Access Compliance Report

Public Rights-of-Way

(Curb Ramps)

Intersection ID: 6766	Main Street: INDIAN RIDGE LN	Cross Street: WINDING CANYON DR	Location: W
ADA ID: 6DDBD0EC98A8	Ramp Type: Perp	Initial Pass/Fail: Fail	Overall Compliance: No
Severity Score: 12.5			
Codes/Mitigation Info/Possible Solution		Field Measurements/Component Compliance

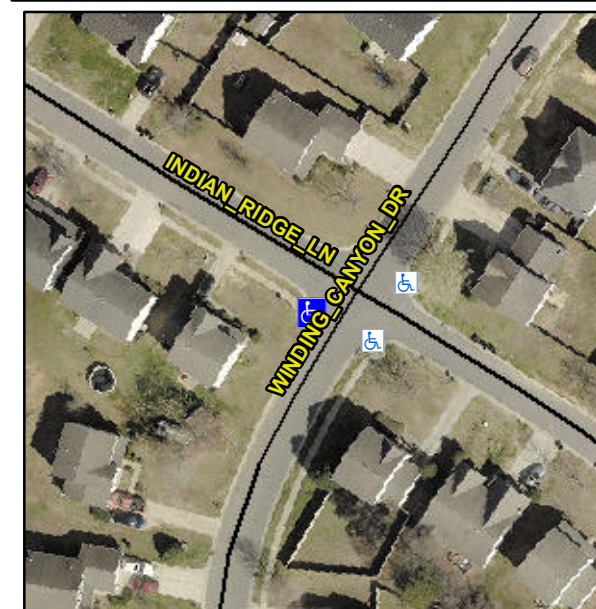
R304.5.3

Compliance	Description	Data	Compliance	Description	Data
N/A	Ramp Length (in)	51.0	Yes	Ramp Slope (%)	6.1
Yes	Ramp Width (in)	48.0	No	Ramp XSlope (%)	5.3
N/A	Flare Type LT	N/A	N/A	Flare Type RT	N/A
N/A	Flare Slope LT (%)	N/A	N/A	Flare Slope RT (%)	N/A
N/A	Flare Traversable LT?	N/A	N/A	Flare Traversable RT?	N/A
N/A	Landing Length (in)	N/A	N/A	DWS Provided?	N/A
N/A	Landing Width (in)	N/A	N/A	DWS Contrast?	N/A
N/A	Landing Slope (%)	N/A	N/A	DWS Length (in)	N/A
N/A	Landing X Slope (%)	N/A	N/A	DWS Full Width?	N/A
N/A	Landing Curb? (Y/N)	N/A	N/A	DWS Offset (in)	N/A
N/A	Shared Landing?	N/A			
N/A	Gutter Ponding?	N/A	N/A	Gutter Slope (%)	N/A
N/A	Gutter Lip Ht (in)	1.0	N/A	Gutter X Slope (%)	N/A
N/A	Painted X Walk1?	No	N/A	Painted X Walk2?	N/A
	X Walk 1 Direction	To SE		X Walk 2 Direction	N/A
N/A	X Walk 1 Width (in)	N/A	N/A	X Walk 2 Width (in)	N/A
	X Walk 1 Slope (%)	8.3		X Walk 2 Slope (%)	N/A
	X Walk 1 X Slope (%)	3.3		X Walk 2 X Slope (%)	N/A

Remove & Replace Entire Ramp.
